**MEMORANDUM-06**

SUBJECT: **Stormwater Management/Site Plans Review**  
***Resubmission dated August 11, 2023***  
Verona Sunset Urban Renewal, LLC  
One Sunset Avenue  
Block 303, Lot 4 (Verona)  
Block 301, Lots 5 and Block 401, Lot 1 (Montclair)  
Township of Verona  
Essex County, New Jersey  
Our File No. VAES-104

**Figure 1.** Proposed model set up adjustment

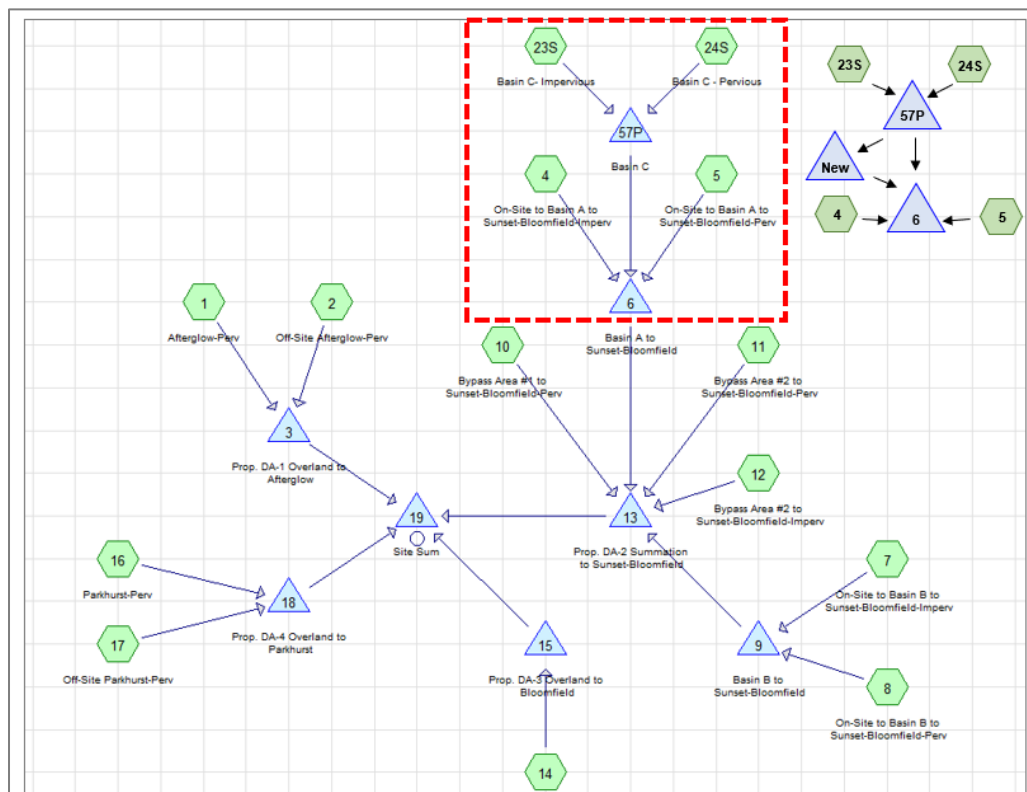
After reviewing the HydroCAD post-development run, it could be noticed that the portion of the model corresponding to the bioretention needs to be fixed.

The component identified as "57P" (Basin C) receives the runoff from subcatchments "23S" (Basin C - Impervious) and "24S" (Basin C - Pervious). The component ("57P") displays one outlet, which does not properly represent how the flow should be routed.

The Applicant shall set up "57P" with two outlets: primary and secondary. The primary will route the flow through the subsurface bioretention basin. The secondary will route any excess flow through the 5-inch orifice. Both outlets will discharge into the 15-inch HDPE pipe and, then, to the component identified as "6" (Basin A to Sunset-Bloomfield). See Figure 1.

Action: Address and resubmit.
